SUBJECT: Menard's Preliminary Plan Review
County Road 42 and Johnny Cake Ridge Road

The following are comments regarding the Menard's Preliminary Plan Review dated June 19, 2018. Please include these items as conditions to approval.

Re: Hydraulic Analysis – Water Main Analysis – Menards Site
Apple Valley Water Distribution System

Date: March 23, 2018
To: City of Apple Valley, MN
From: Bryan T. Nemeth, P.E., PTOE
Michael Boex, P.E.
Subject: Traffic Impact Study Review – Supplemental Traffic Forecast
Menards Development

Figure 1B

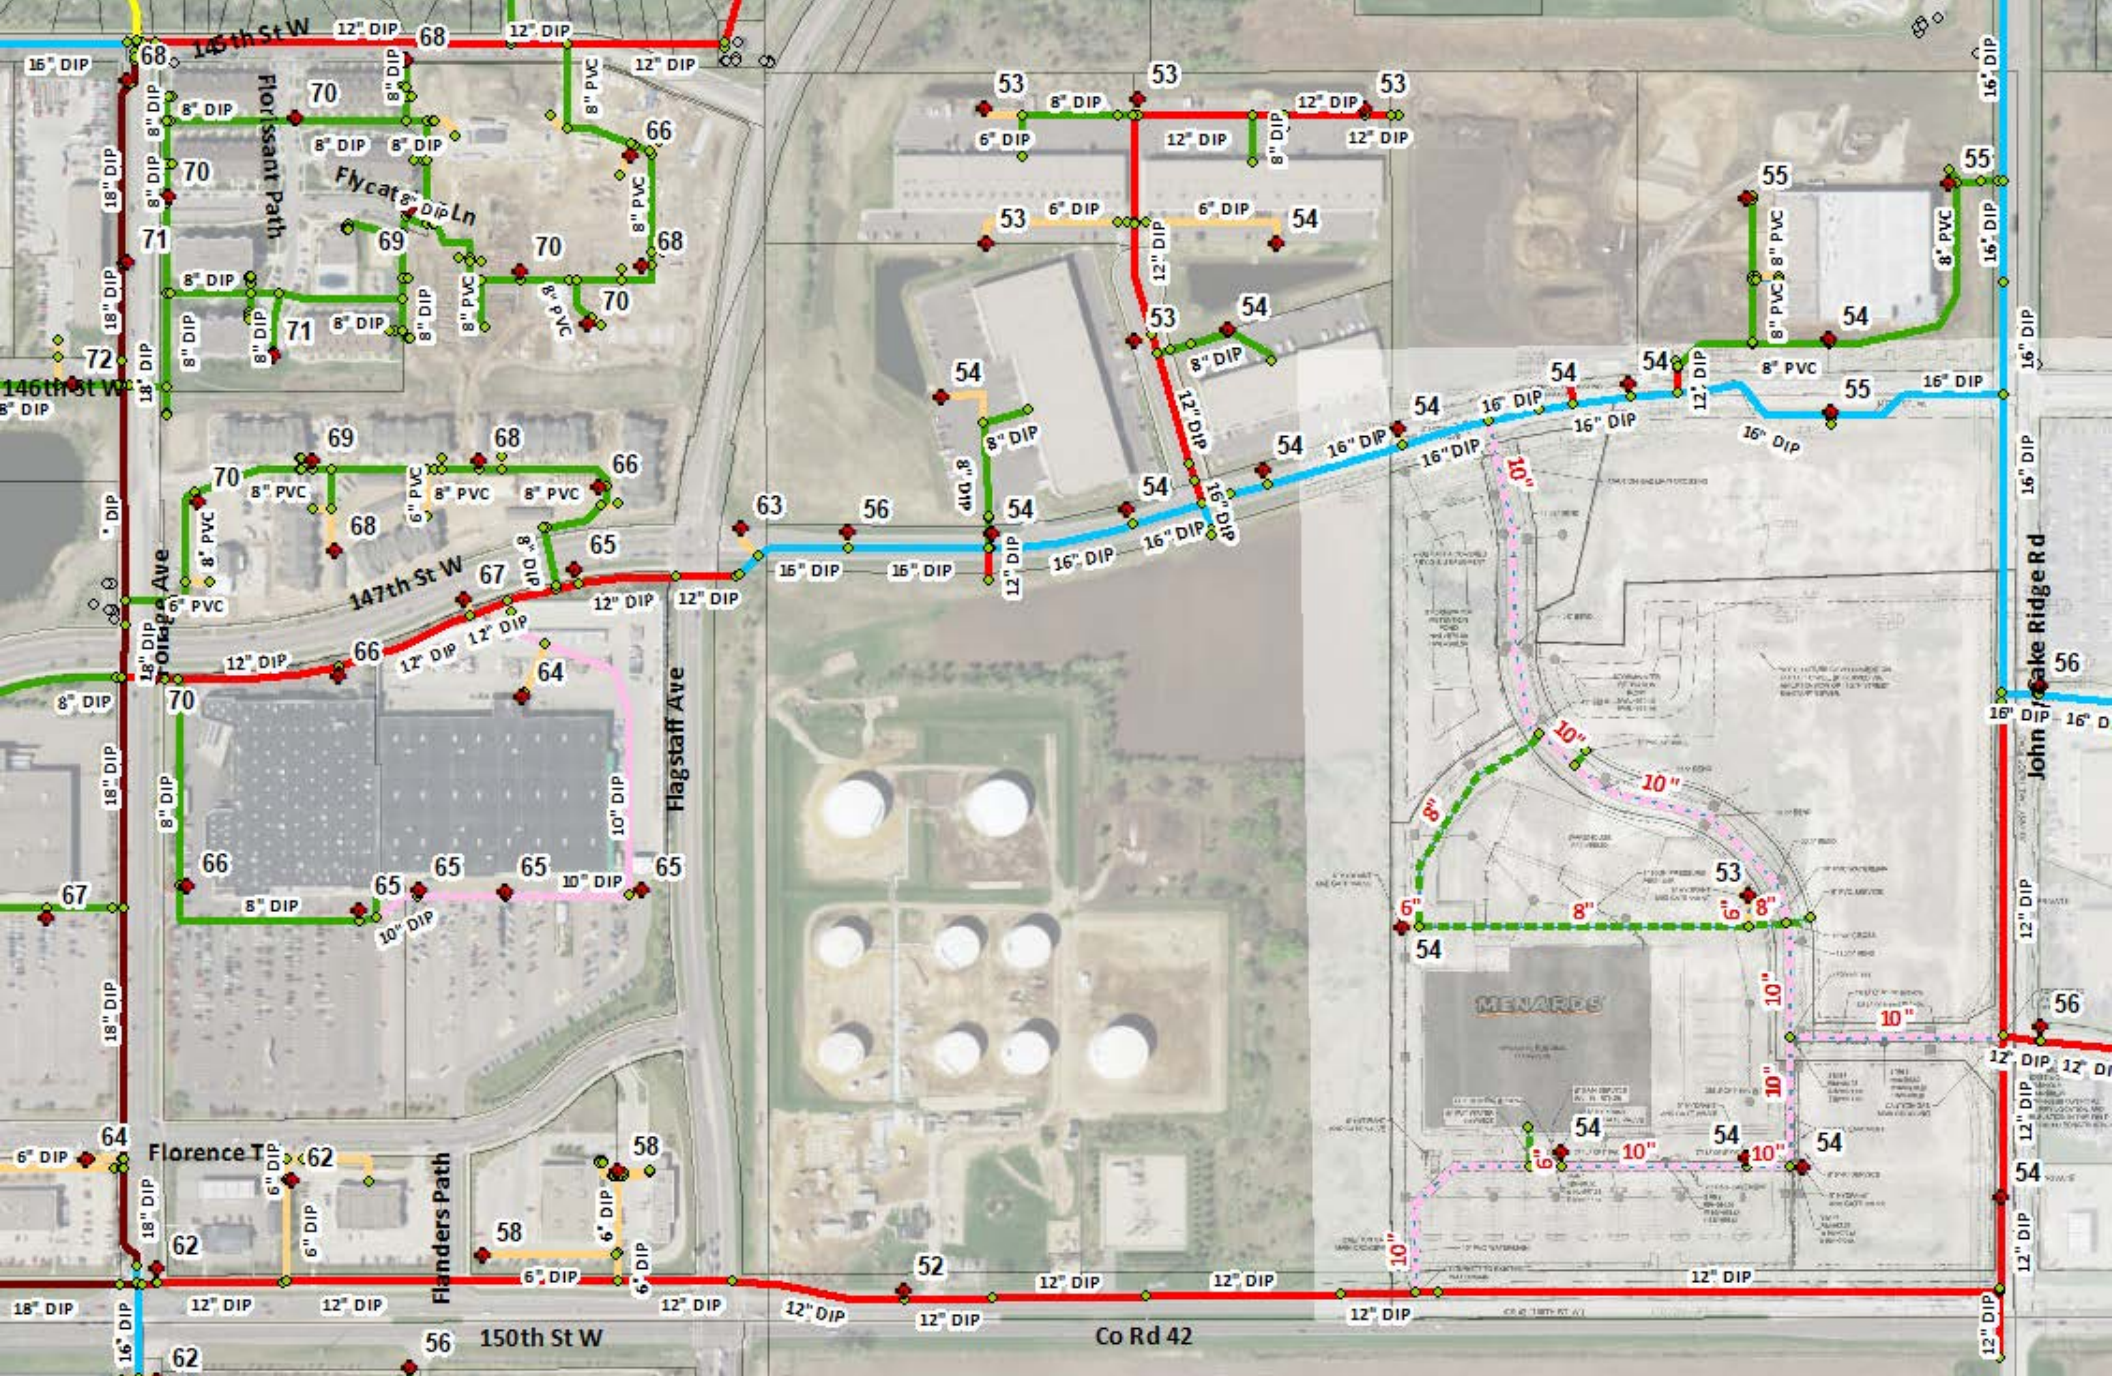
- Pressure Analysis – Average pressures shown in Figure 1A
- Fire Flow Analysis – Available fire flow at 20 psi residual shown in Figure 1B.

- Fireflows ranged from 3,600 gpm to 5,700 gpm depending on the location within the development.
 - Specific fire flow requirements for the Menards facility were not available.
 - Desired available fireflow for commercial facilities is typically 3,500 gpm.
 - Based on the current water main planned for the facility, available fireflows would be greater than 3,500 gpm.

Figure 1A

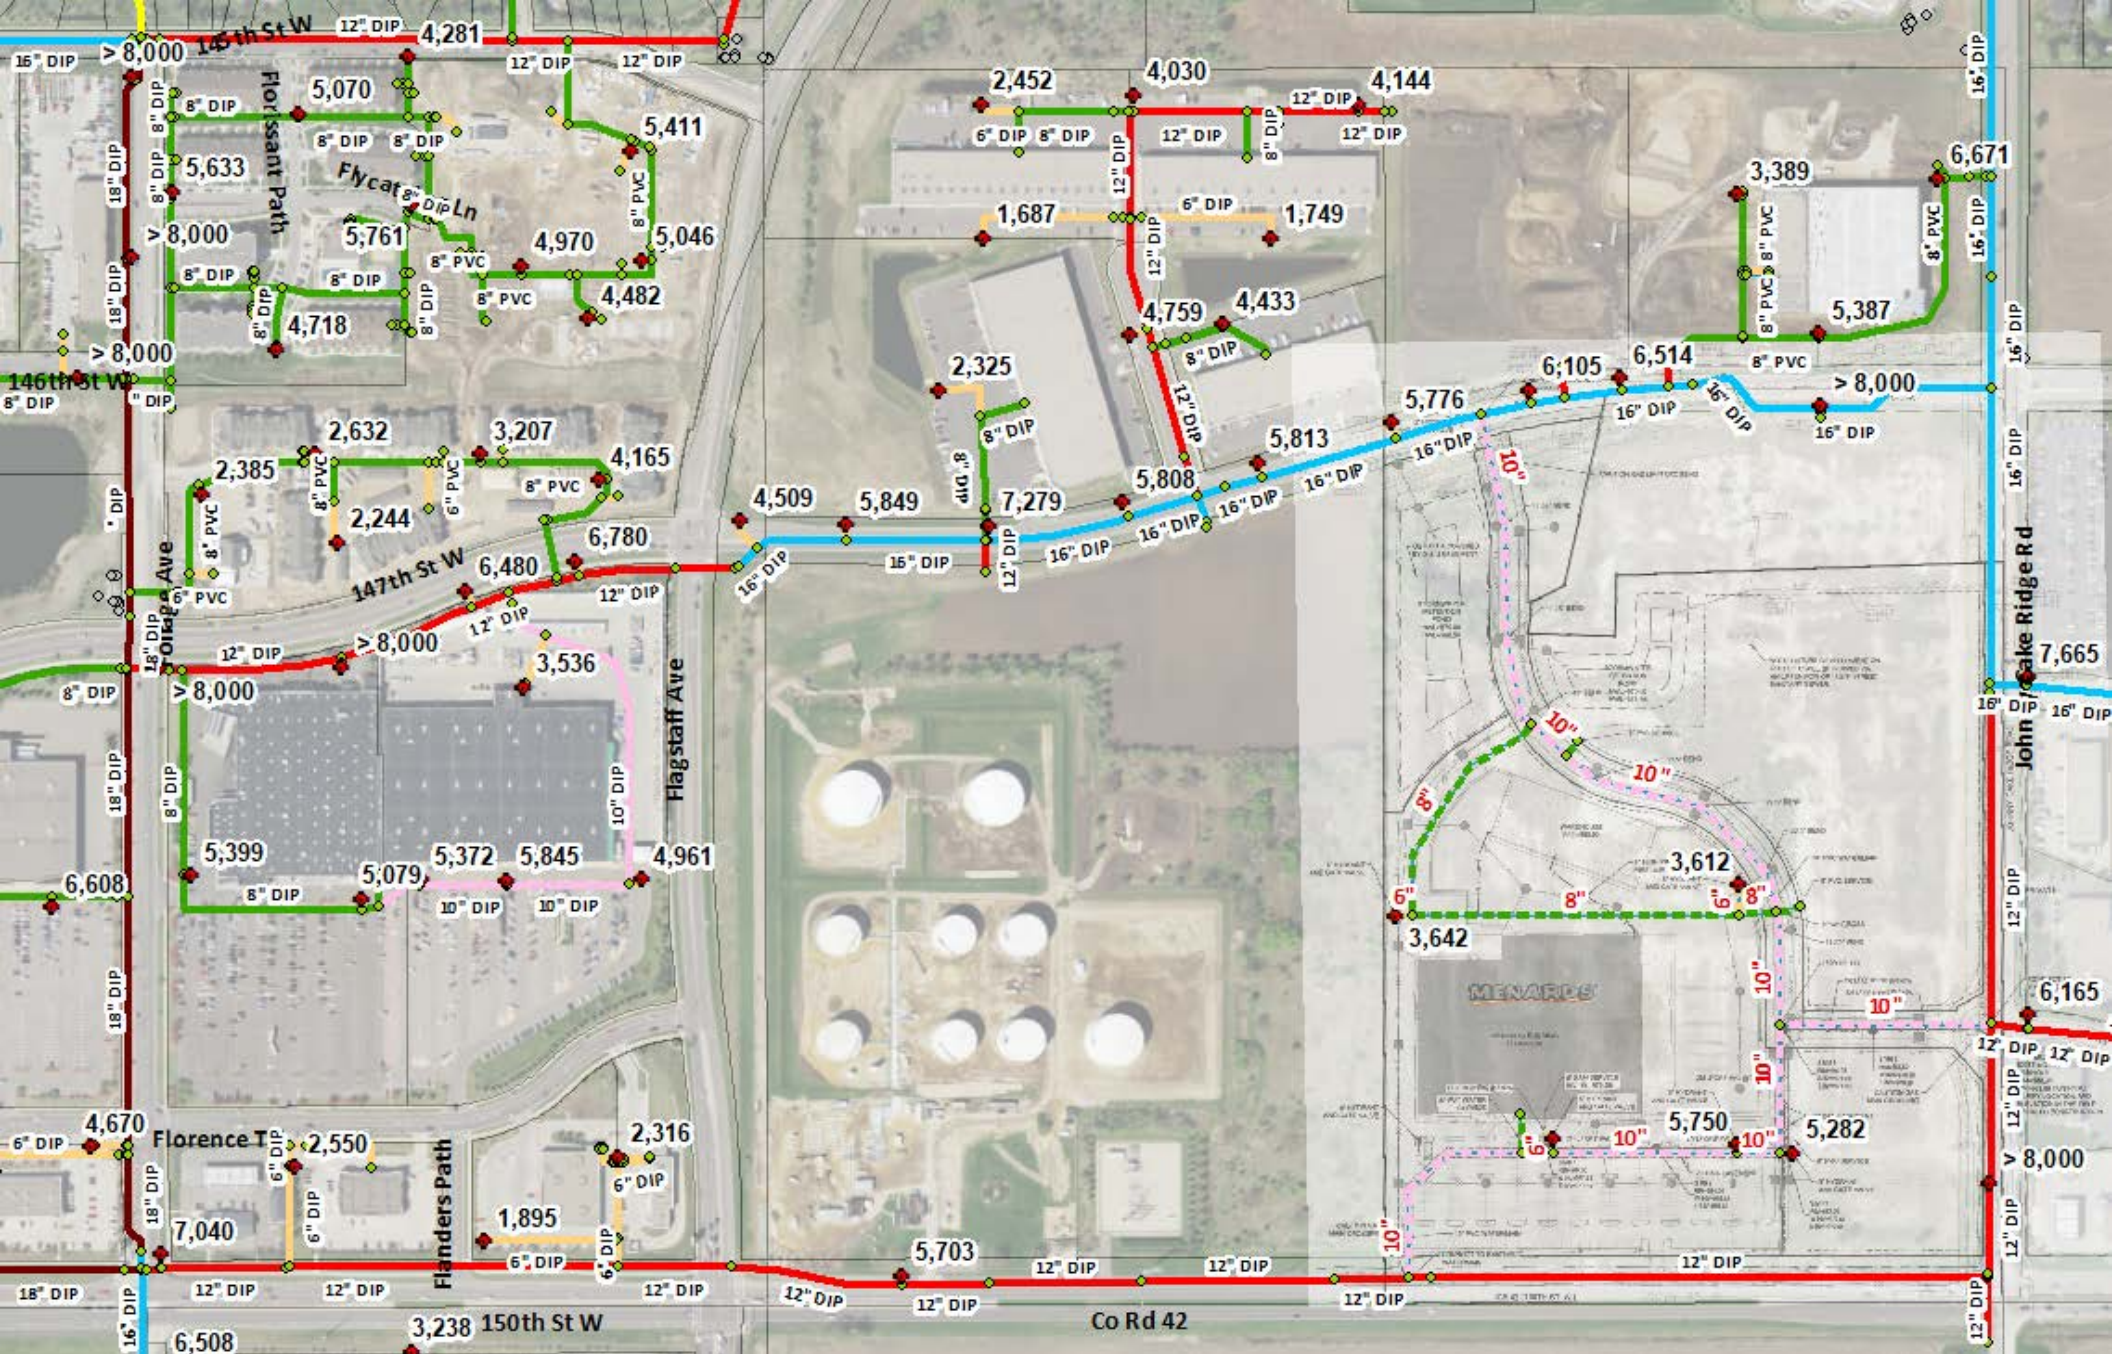
- Pressures ranged from 53 to 54 psi. These pressures are adequate for this type of development.
